PLANT NAME: Monticello

RESPONSES TO AEC

QUESTIONS ON MONTICELLO HIGH ENERGY  
LINE BREAKS OUTSIDE OF CONTAINMENT

SECTION - CC

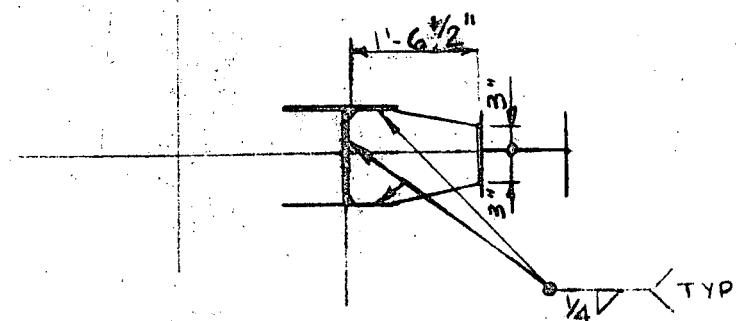
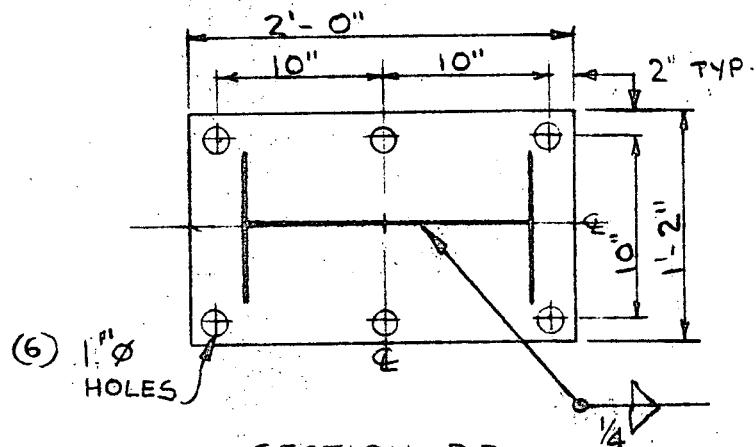
3. QUESTION: Submit details of the additional protection mentioned in paragraph 6.2.2(1).

ANSWER: The additional protection envisioned at the time of the report was a plate protecting the turbine building mezzanine floor (elevation 931'0") from a jet of water impinging on the floor. This would also have provided pipe whip protection. Further analysis of the break and break locations resulted in the following:

b. Pipe Whip

In order to provide protection to the mezzanine floor against pipe whip, four restraints will be added. Detail drawings of the pipe restraints are attached. The design load for the pipe restraint was 161 kips.

With the addition of the four pipe restraints, the mezzanine floor will be protected; thereby insuring safe shutdown of the plant following a feedwater line break.
